Updates to the simulation model

Apr 14 2021

Feedback from the engineering review

Beampipe

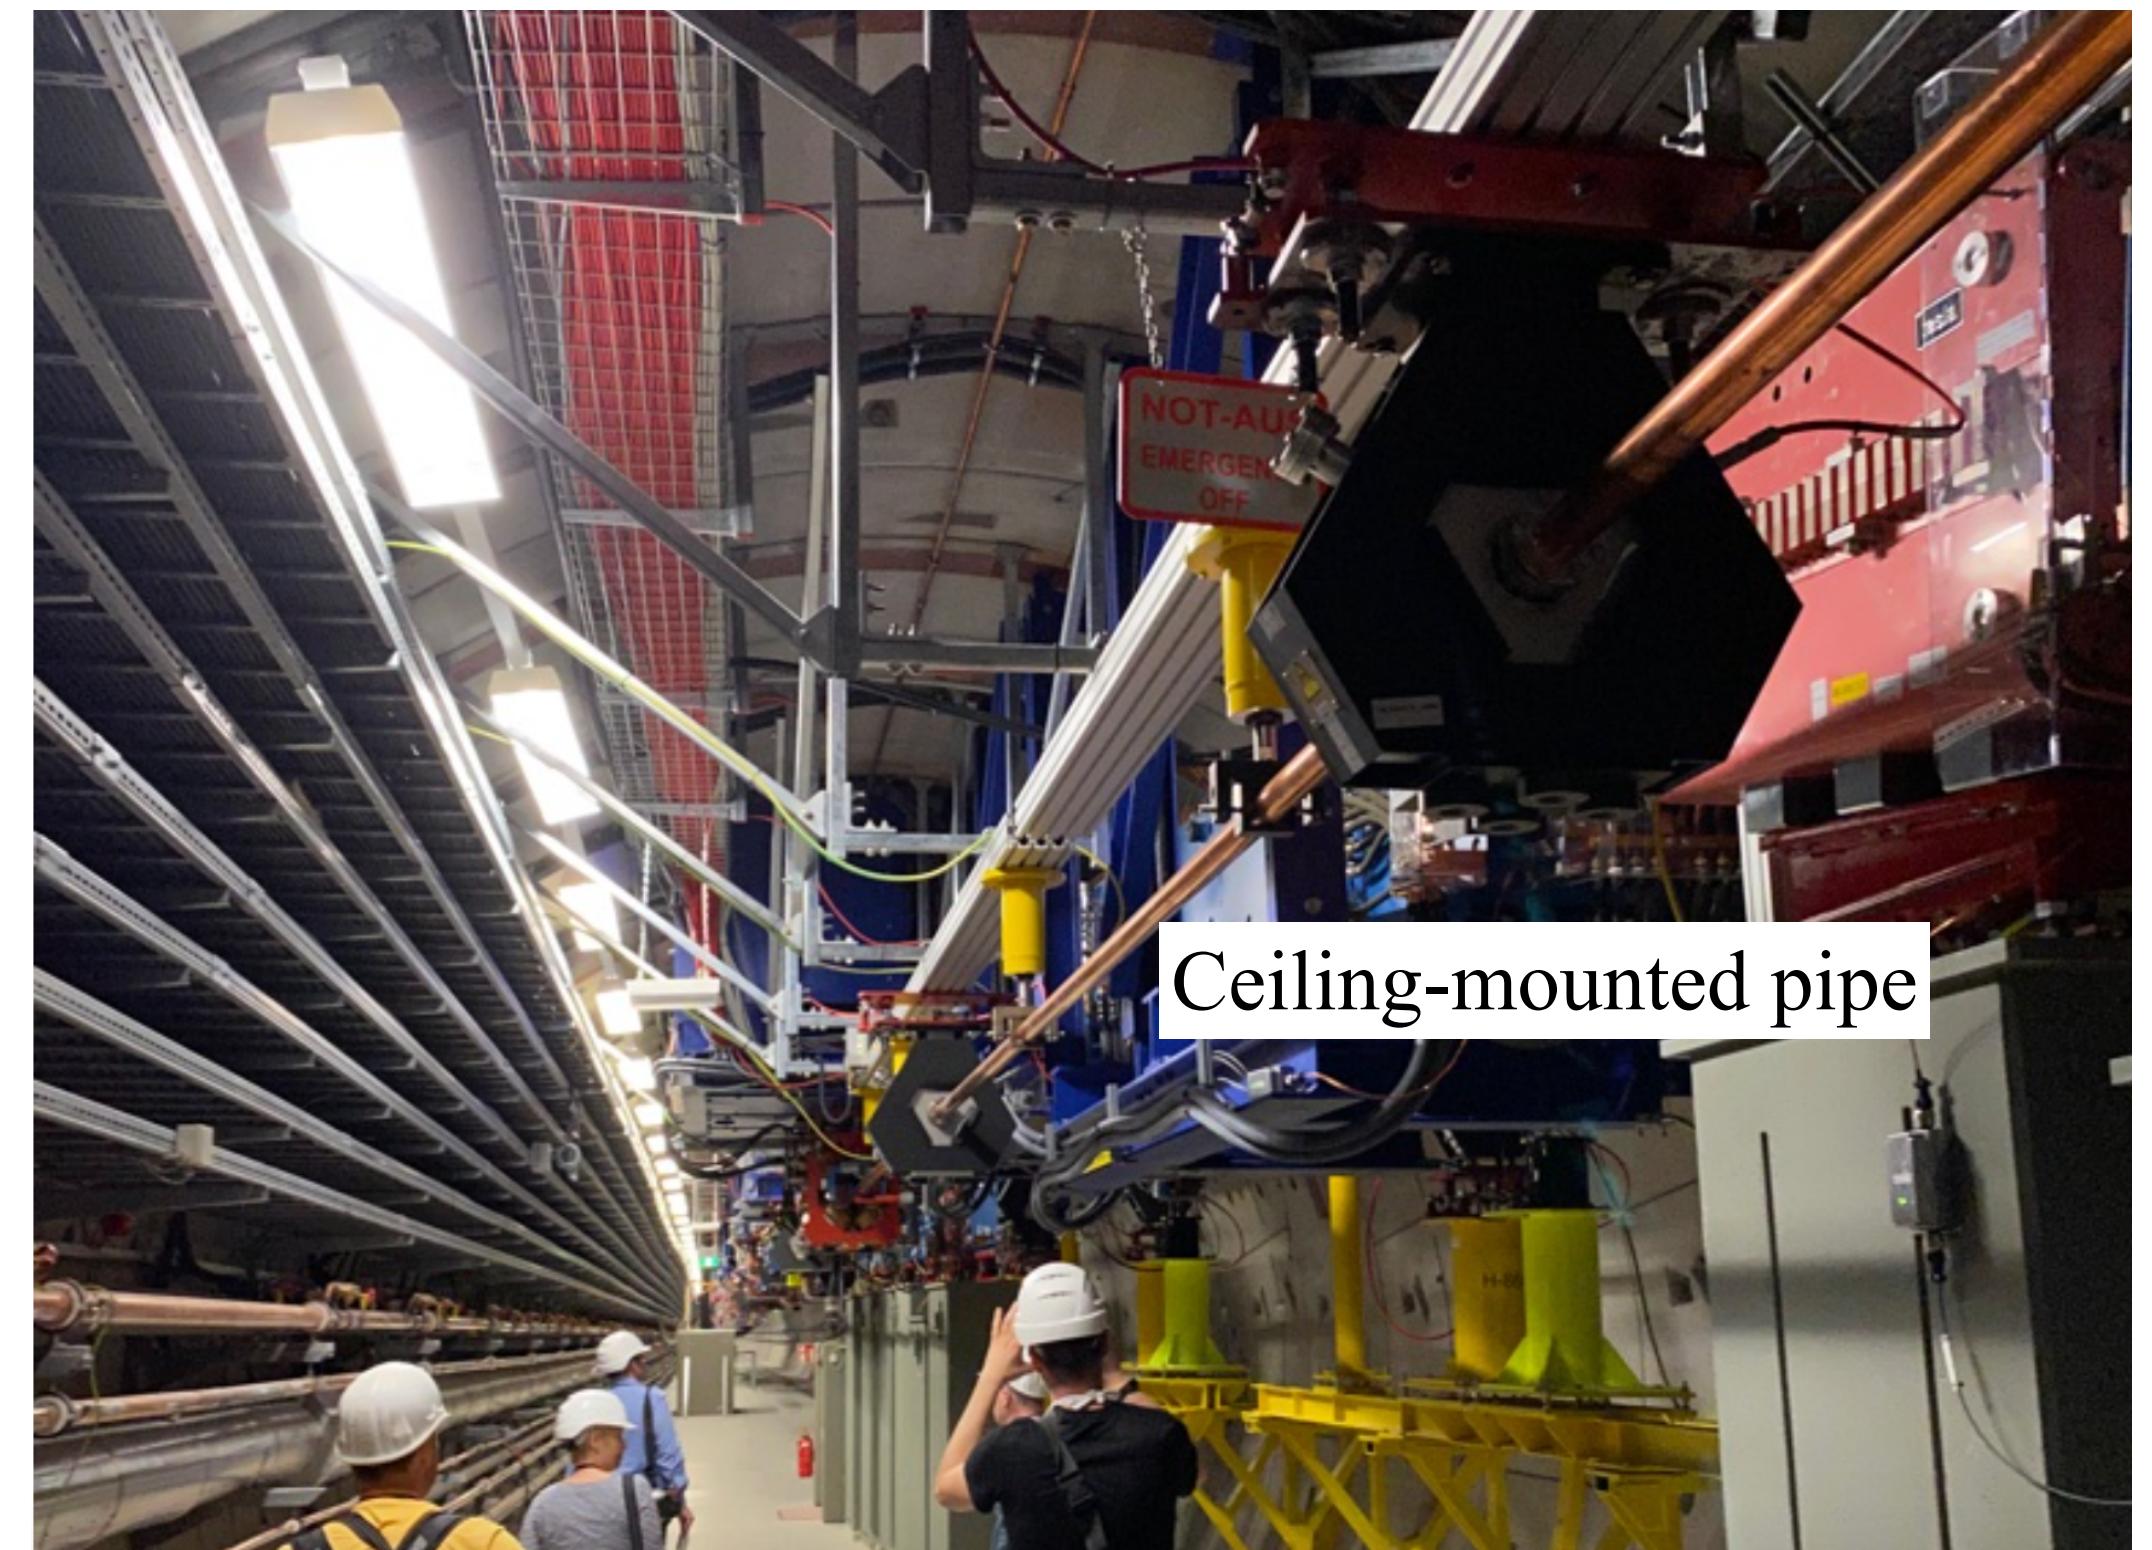
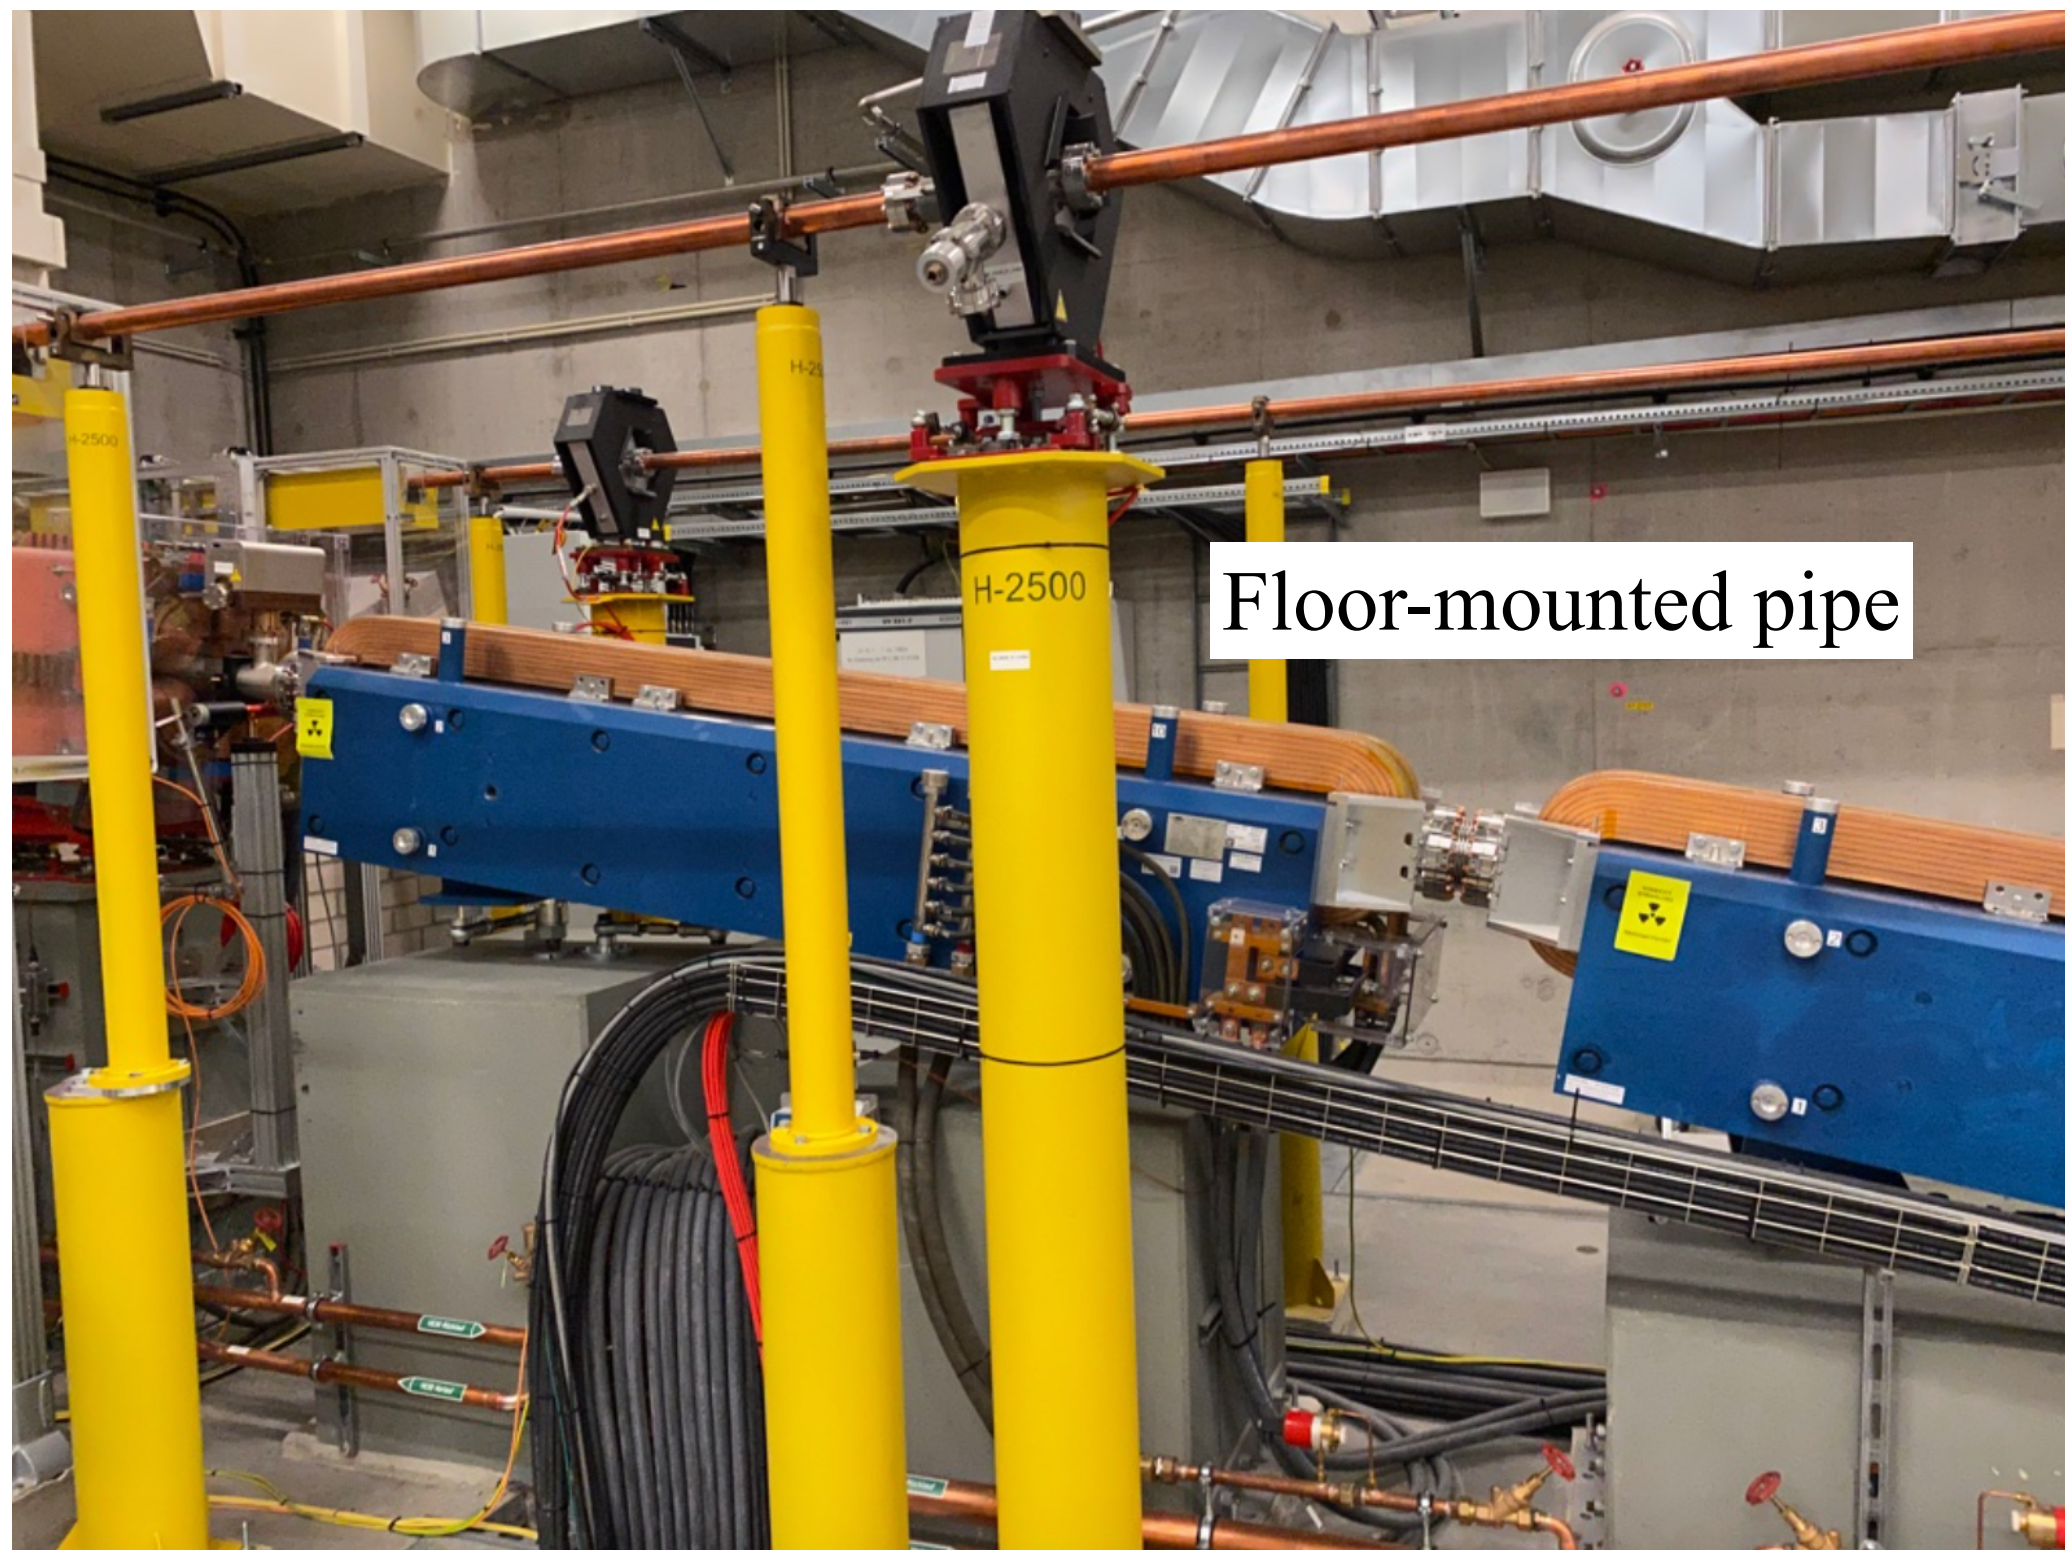
- ◉ Must add the pipe mounts in the simulation:
 - ◉ need the drawings
 - ◉ how many of these should be used to prevent sagging?
- ◉ Will probably need to use the ceiling mounts (too crowded otherwise)
- ◉ Need to specify the vacuum points along the pipe

Shielding & dumps

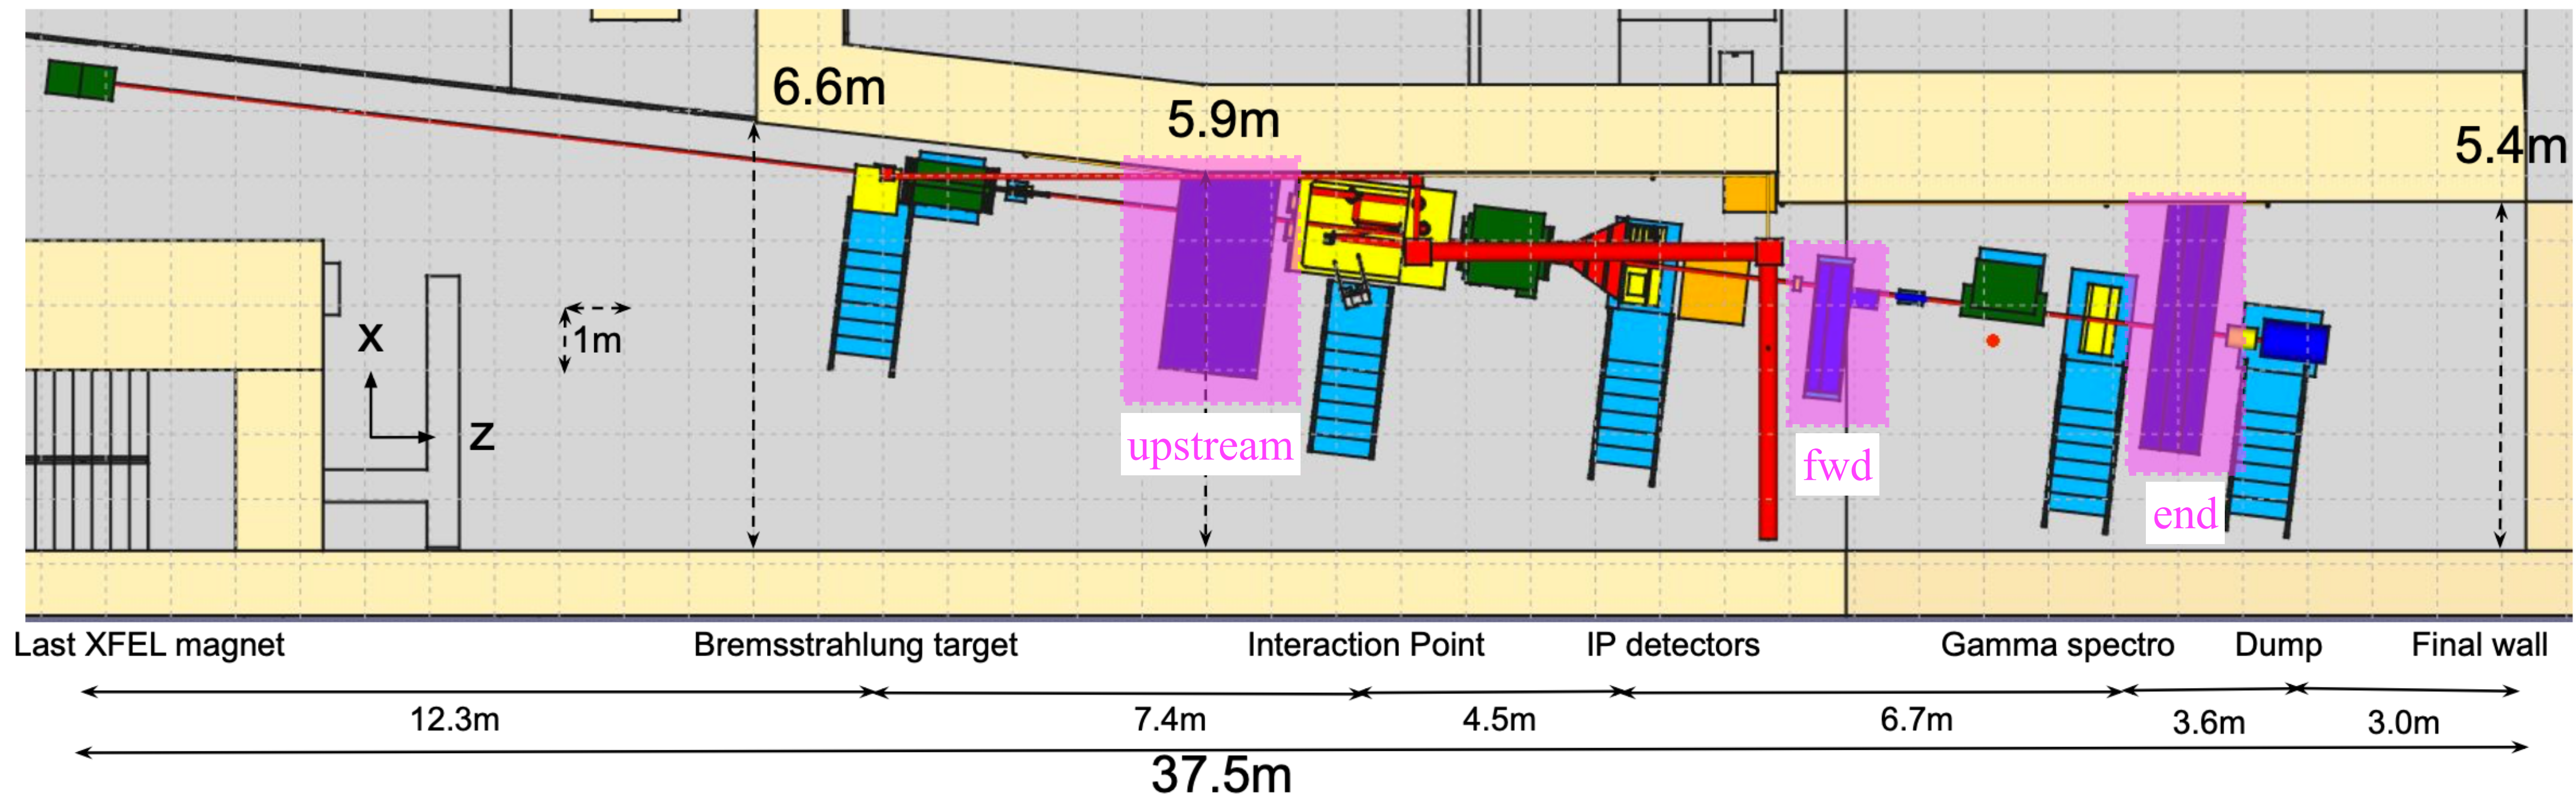
- Way too heavy (Iron+Aluminium now) and too large: **upstream**: $xyz=\{3\text{m},4\text{m},1.5\text{m}\}$, 192T(!), **fwd**: $xyz=\{2\text{m},1\text{m},1\text{m}\}$, 1.9m above a concrete block, 13.5T, **end**: $xyz=\{4\text{m},4\text{m},0.9\text{m}\}$, 50T(!)
- All shielding should be sitting on concrete blocks (cannot assume a thick metal wall sitting on the floor)
 - check idea to integrate polymers in the dumps to stop (“thermalise”) neutrons more efficiently
 - fwd dump needs to be rectangular and fully enclosed in the concrete
- Need to run some tests in GEANT4 to see how the metal budget can be minimised

IP chambers connectivity and vacuum

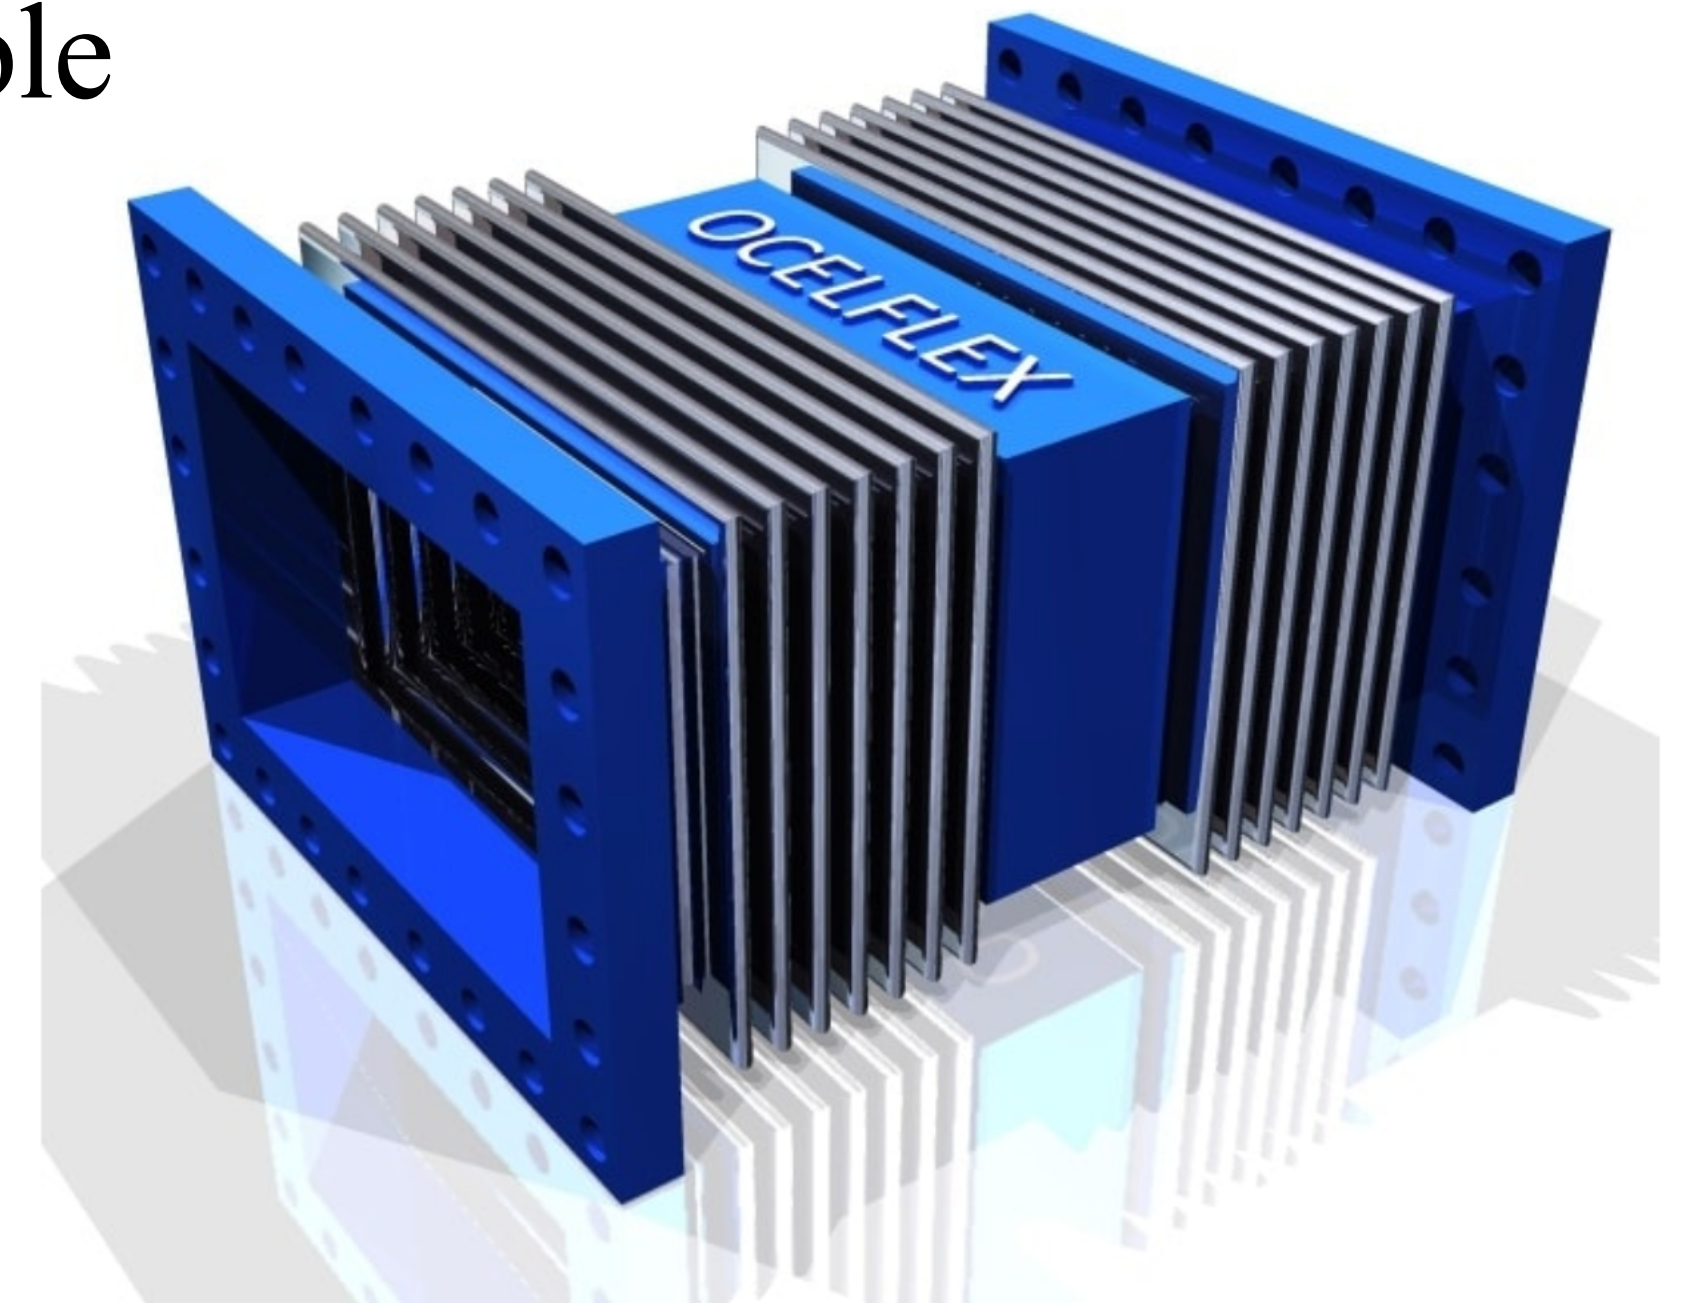
- ◉ IP chamber should be connected directly to the dipole (rectangular) chamber with a flexible bellow [example] which can hold the vacuum
- ◉ Must have gate-valve in the entrance and exit of the IP chamber (already planned)
- ◉ Not enough space (~ 17 cm) between the IP chamber and the dipole
 - ◉ IP chamber should be taken a bit upstream if possible
